**ZTE CORPORATION****Product Change Description**

[Smart Tab 10]  
[ZTE Corporation]

is the variant of the initial certified product,

**1、WIFI antenna change:**

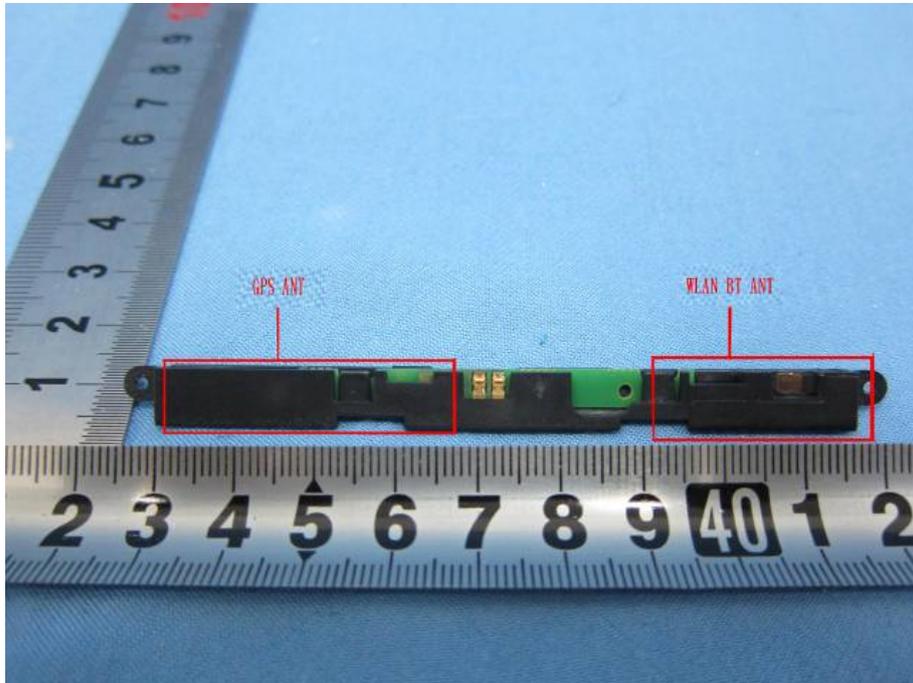
Before:

Antenna connects to RF module through RF cable which fix on pcb by RF connector.

After:

Antenna connects to RF module through RF cable which soldered on antenna.

The changes of Wifi antenna does not affect BT. The new Wifi antenna has the good performance.

**2、PCB Layout changes:**

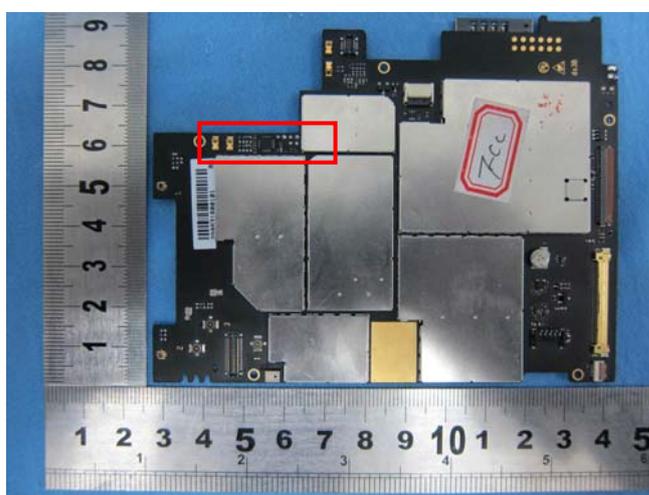
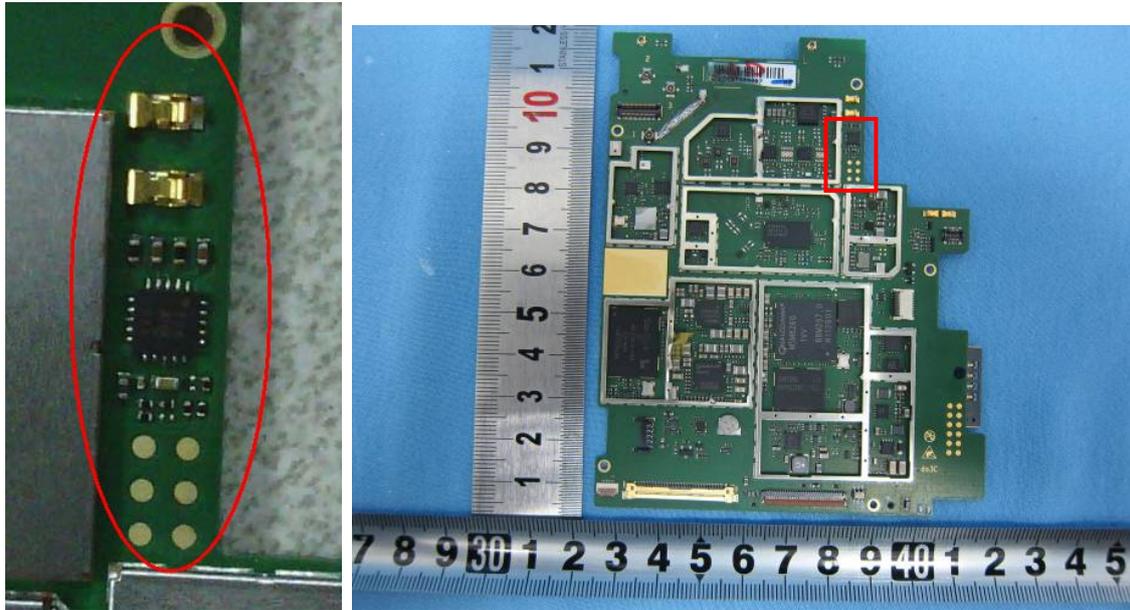
The Layout of band Changes:

Before:

After:

Delete the unnecessary components, and replace the test points.

Front-cover:

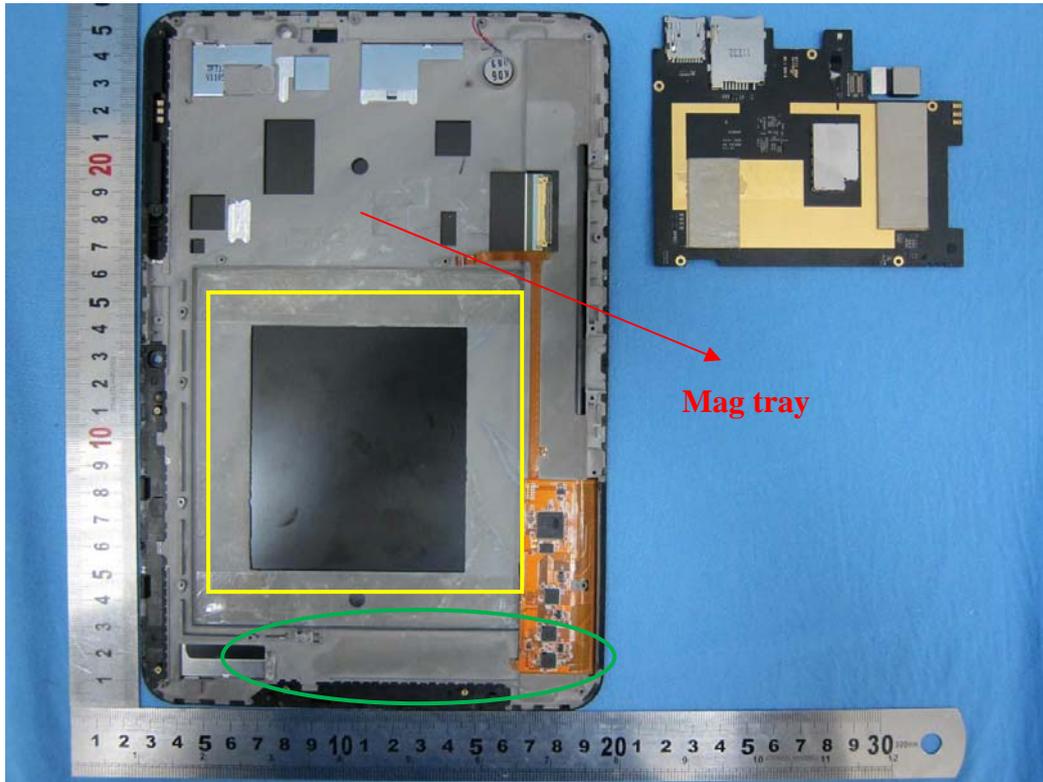
Mechanical modification: In order to reduce white line or white dots on the LCD display area.

- 1) Reduced the length of rib of battery: yellow part of mag tray.
- 2) Add a reinforcing rib: green part of mag tray.
- 3) Removed 0.1mm in LCD area: another side of mag tray beside to LCD ,it can not be seen clearly in this picture.
- 4) Removed 0.4 mm in LCD PCB area: another side of mag tray beside to LCD, it can not seen clearly in this picture.

5) Add two ribs in FPC area : in order to reduce gaps of front shell.

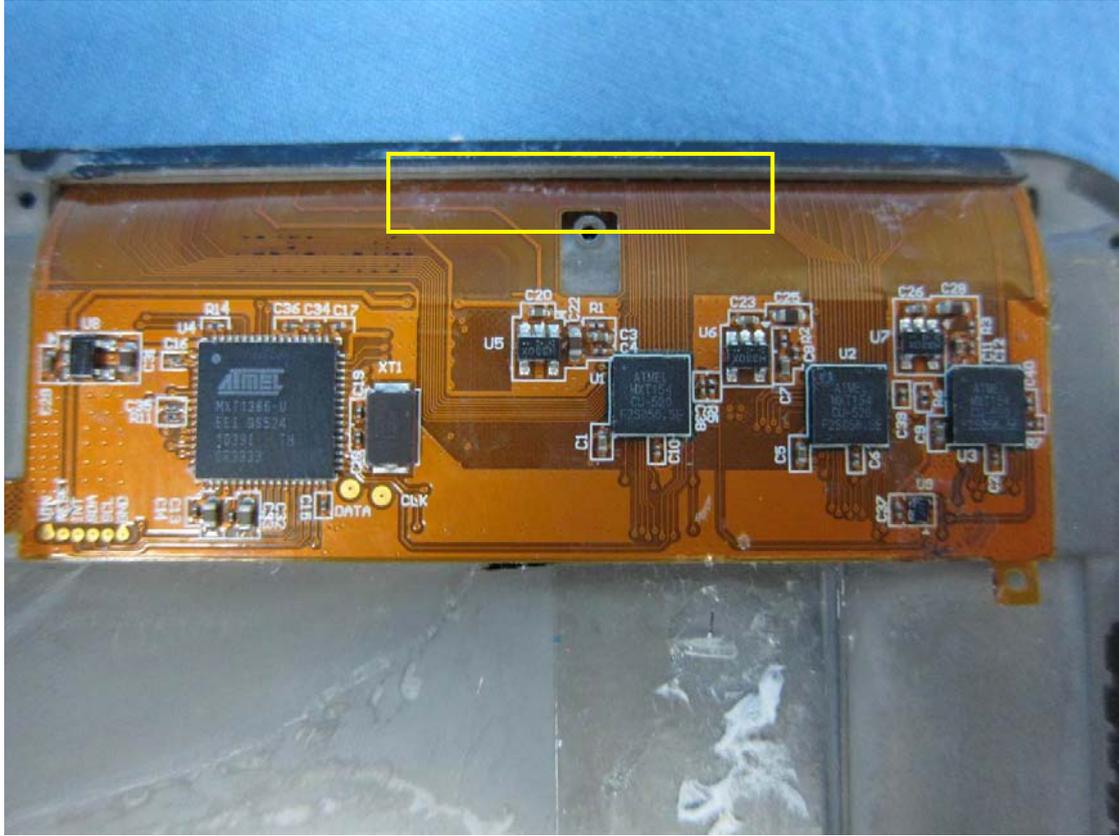
Before:

After:

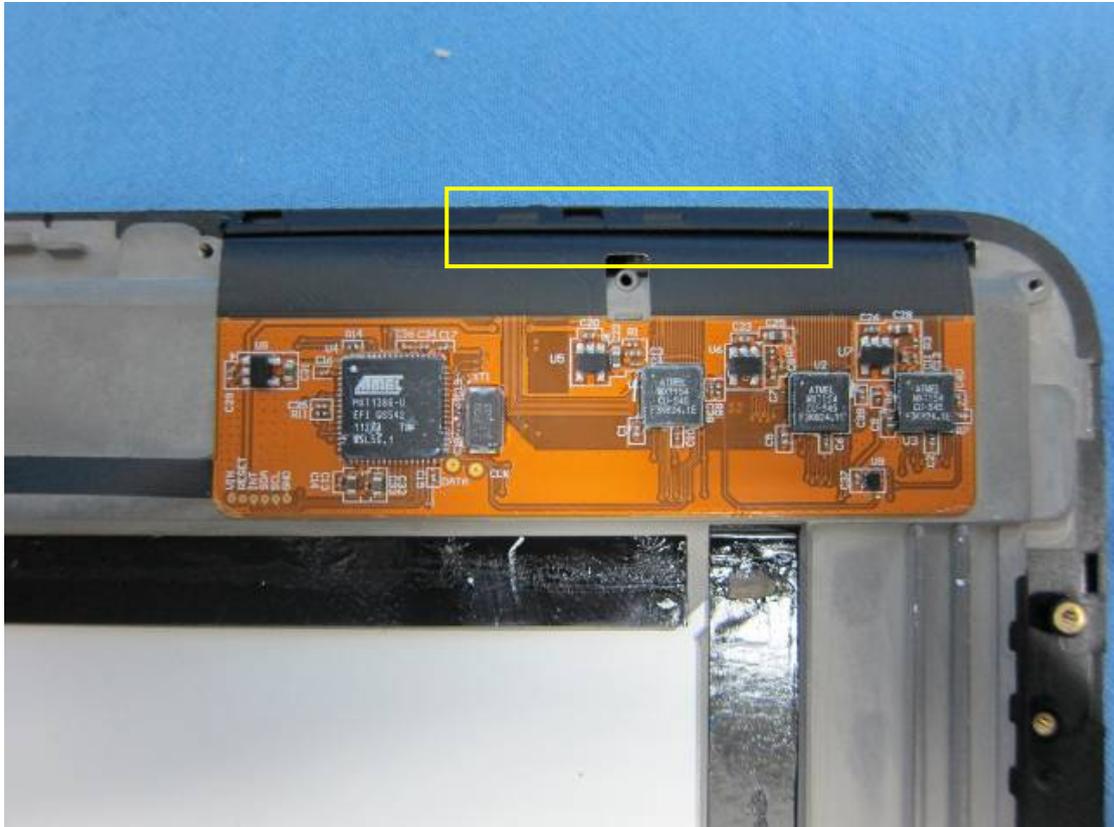
Before:

After:
